JAMES A. FITZPATRICK NUCLEAR POWER PLANT

Amendment No. 57  
License No. DPR-59

ATTACHMENT TO LICENSE AMENDMENT NO. 57

SAFETY EVALUATION BY THE OFFICE OF NUCLEAR REACTOR REGULATION  
SUPPORTING AMENDMENT NO. 57 TO FACILITY OPERATING LICENSE NO. DPR-59  
POWER AUTHORITY OF THE STATE OF NEW YORK  
JAMES A. FITZPATRICK NUCLEAR POWER PLANT  
DOCKET NO. 50-333

FIGURE 6.2-1

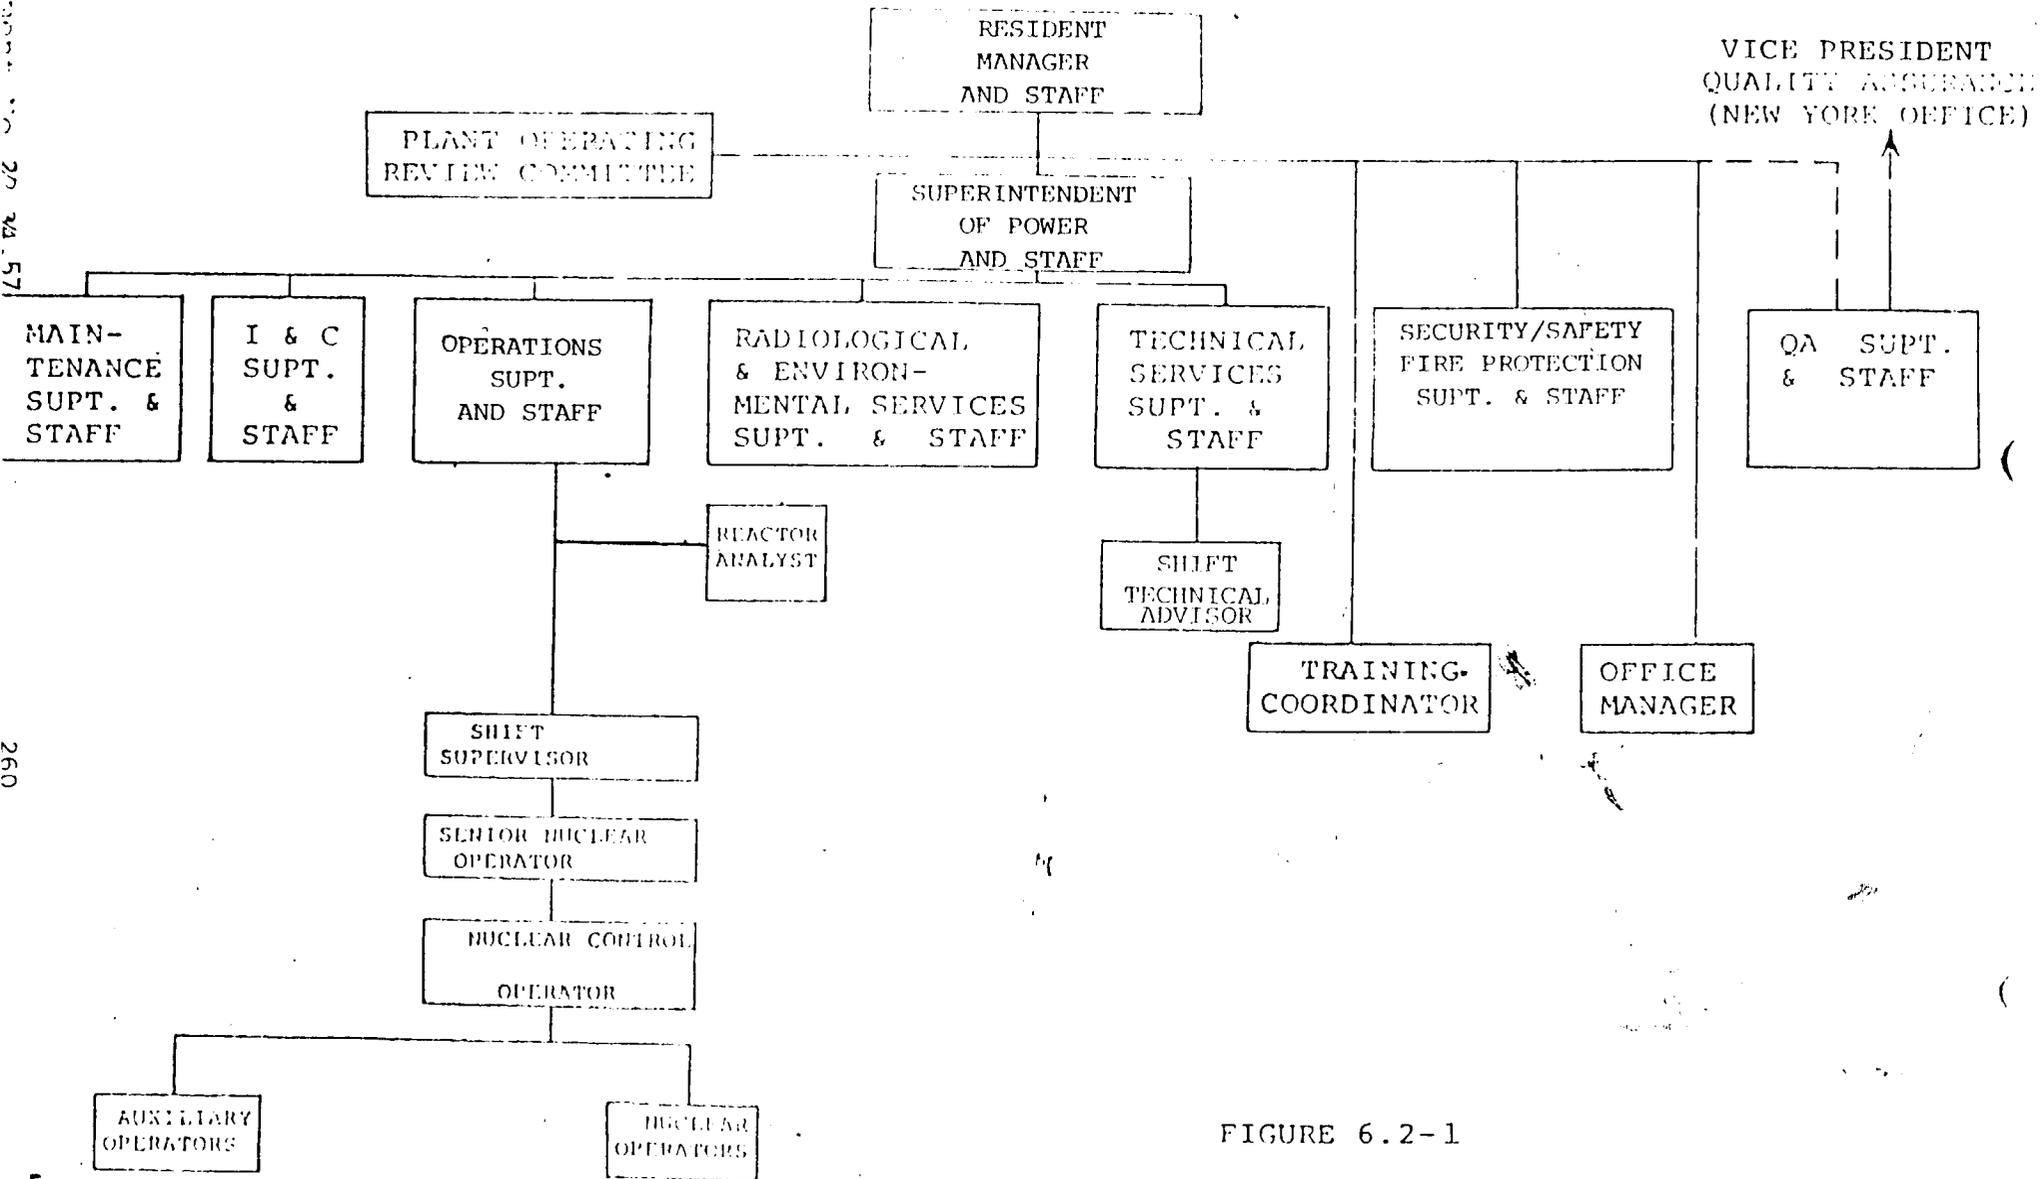
Our request indicated that the TSs related to minimum shift manning should be revised to reflect the augmentation of an STA. The STA function includes both accident and operating experience assessment. The licensee response proposed TS changes which provide for the Shift Technical Advisor. We have reviewed these changes and conclude that the licensee has satisfied this requirement.
